## **ADDENDUM #3**

**Project Name:**  
**Iowa School for the Deaf (ISD)**  
**IDOE ISD Giangreco Hall Water Infiltration Mitigation**  
**DAS# 9455.00**  
**RFB 945500-01**  
**Addendum #3**  
**Dated: December 03, 2025**

**Date:** 12/2/2025  
**Project:** 9455.00 Iowa School for the Deaf - Giangreco Hall Water Infiltration Mitigation  
**OPN Project Number:** 24843001  
**Client:** State of Iowa  
**Project Location:** 2160 Linden Drive, Cedar Rapids, IA 52403

Supplemental Drawing – Tile Diagram 01

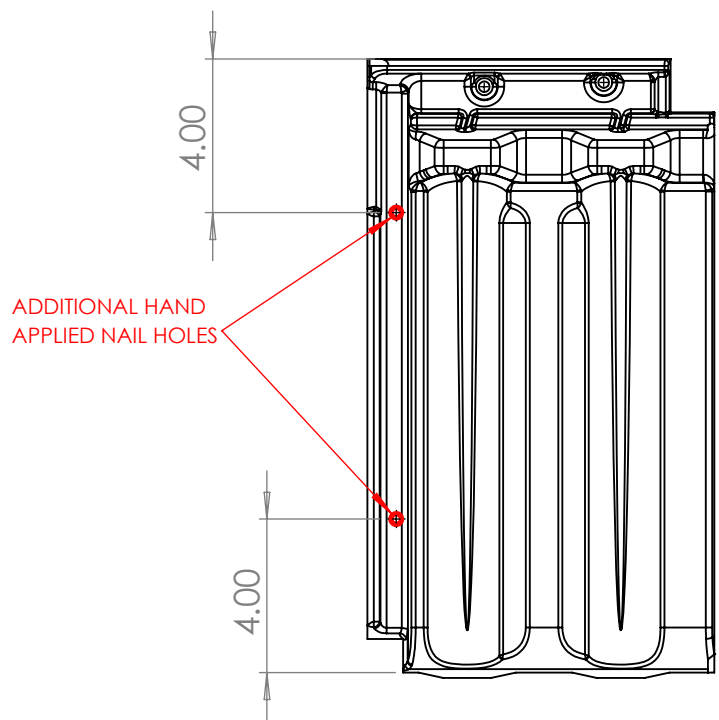
- 1. Add Supplemental Drawing – Tile Diagram 01 with the page number 07 32 13 – 7; The diagram shows the new location of nail holes and the installation of the Tricoya plywood under this course for nailing the new nail holes. Also, the installation of the new underlayment over the Tricoya plywood. The manufacture will provide 1710 tile units with these nail locations.
- 2. Add Supplemental Drawing – D2025-451PTN with the page number 07 32 13 – 8; Diagram shows the additional hand applied nail holes four inches from each end.
- 3. Add Supplemental Drawing – Photograph of the trail samples after firing the clay tile with the page number 07 32 13 – 9.

Tile manufacture will punch two holes in the gutter before firing the clay body.

Use this modification for the top course of the **Base Bid** tile installation. 1710 tiles will be fabricated for this installation method.

New 3/4" tricoya plywood installed with tapcons to the concrete deck for nailing surface of french tile.

New underlayment installed over the plywood and above the slope.

Sheet Number  
**G001**

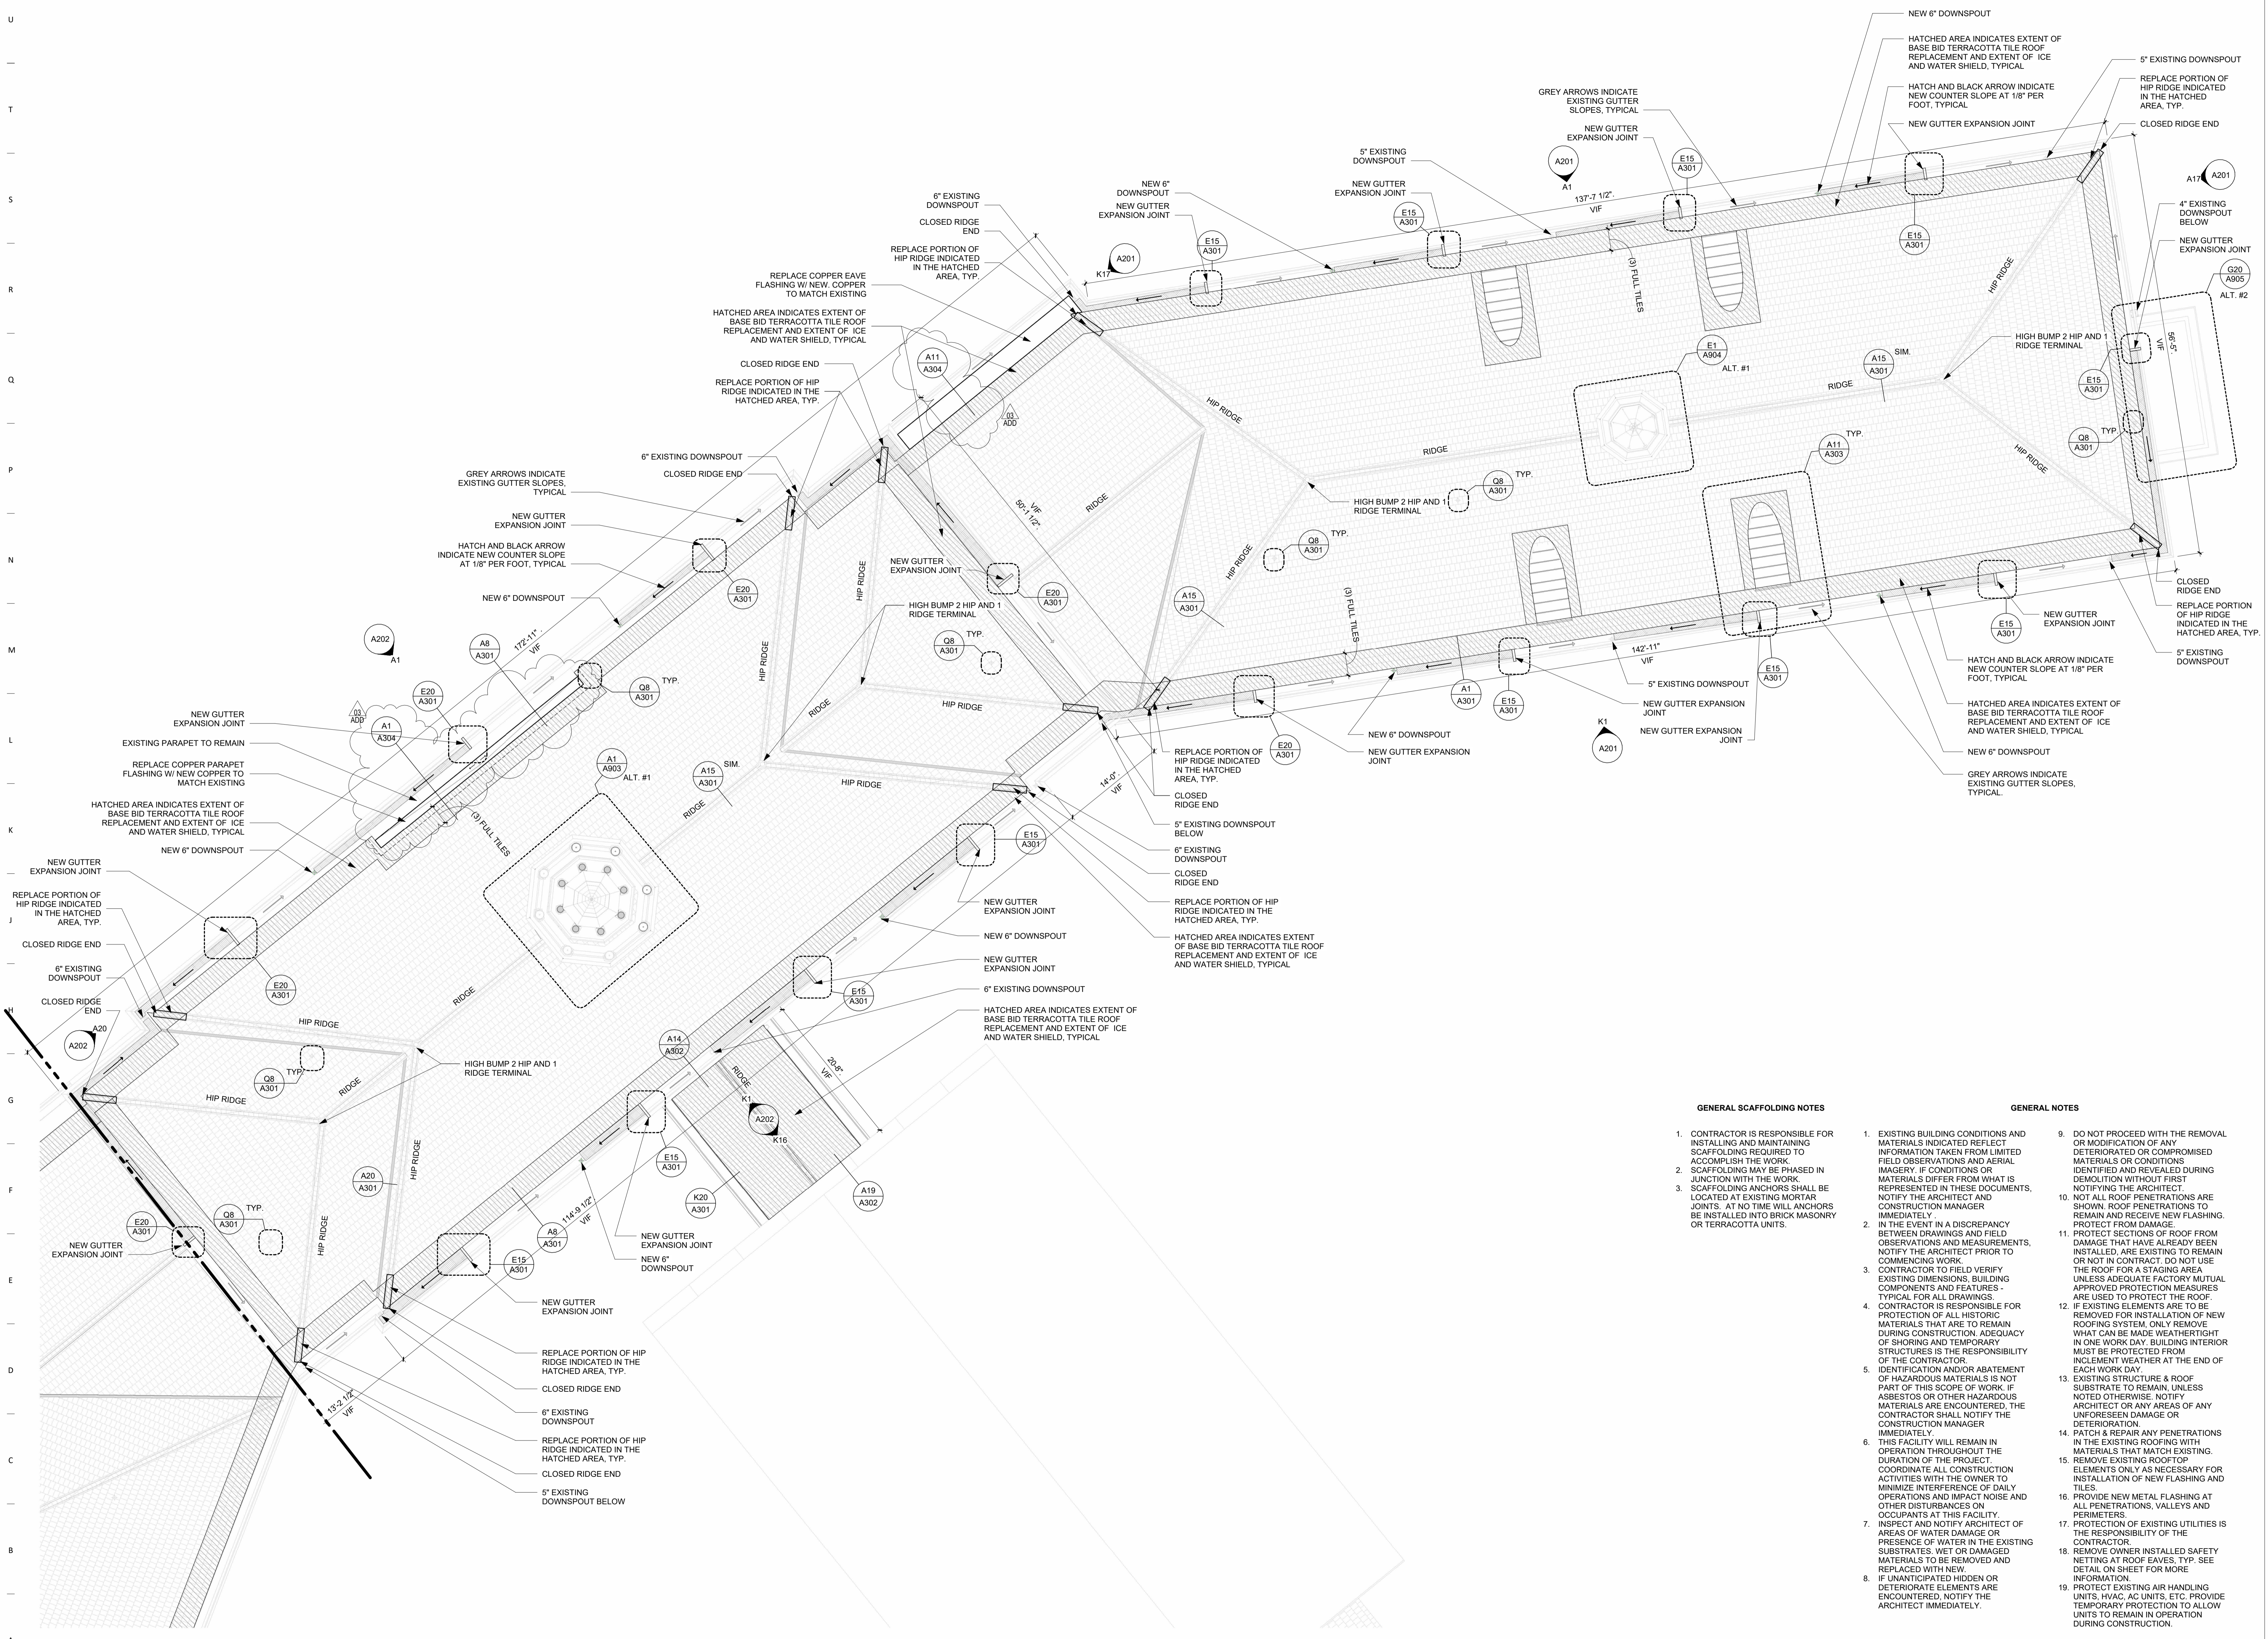
- i. Sheet G001: Add sheet A304 to the list of Architectural Drawings.
- ii. Sheet A100: Add detail A11/A304 to the drawing for the east wing of the building and add detail A1/A304 to the drawing of the center wing.
- iii. Sheet A101: Add detail A11/A304 to the drawing south of the match line for the west wing of the building.
- iv. Sheet A304: Add details A1 and A11 to new sheet for the set.
